Title: MTO2017 Rework of the body near the engine L/H		
AG-SB-2023-06-B-EN	Effective Date: 01.11.2023	Compliance Category: A – MANDATORY B – RECOMMENDED C – OPTIONAL
Applicability		
Aircraft type & model: MTO2017	Affected Serial number(s): All MTO2017 with 915 iS engine built before 2023	
The maintenance manual to be referenced is this stated or subsequent issue.		As per AutoGyro website
This form is the response from AutoGyro GmbH either against a problem found in the product in service requiring a containment or rectification action, or as service information for aircraft modification incorporation. For help, contact airworthiness@auto-gyro.com .

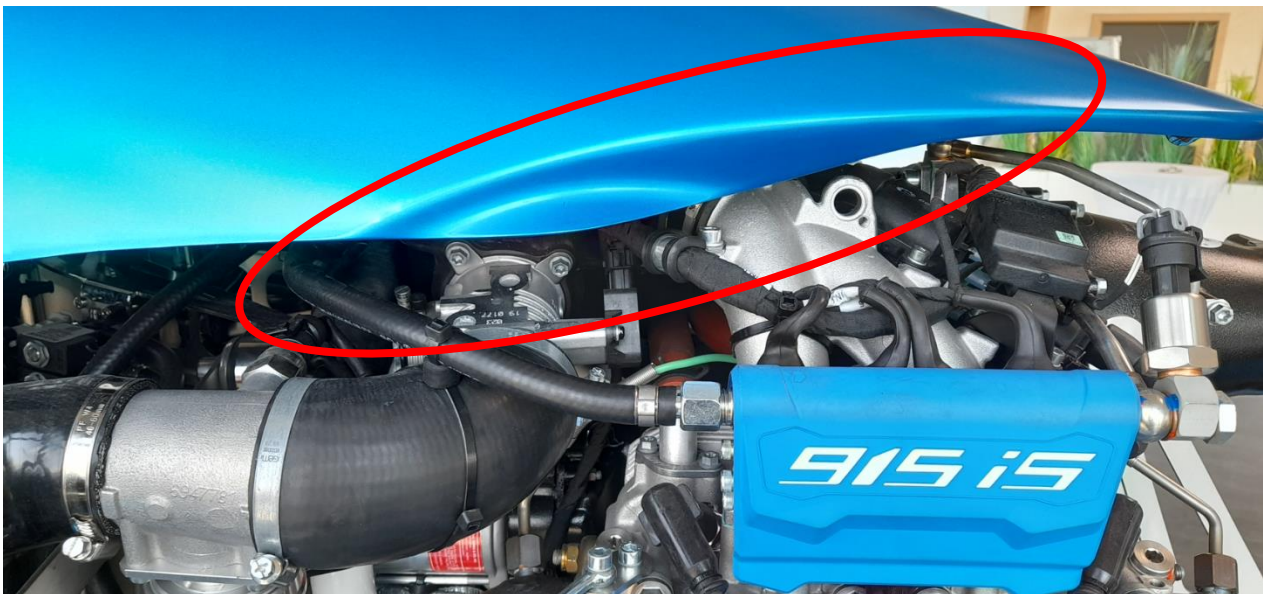
Wiring harness has to be checked for damages before starting the work. Is there no damage visible rework is not necessary.

If there is some kind of damage visible either the body has to be removed for the rework or the engine has to be covered to avoid any dirt getting to the engine.

The new contour of the body must be marked. Rework the body carefully with a dremel to reach a 2cm gap between the harness and the body.
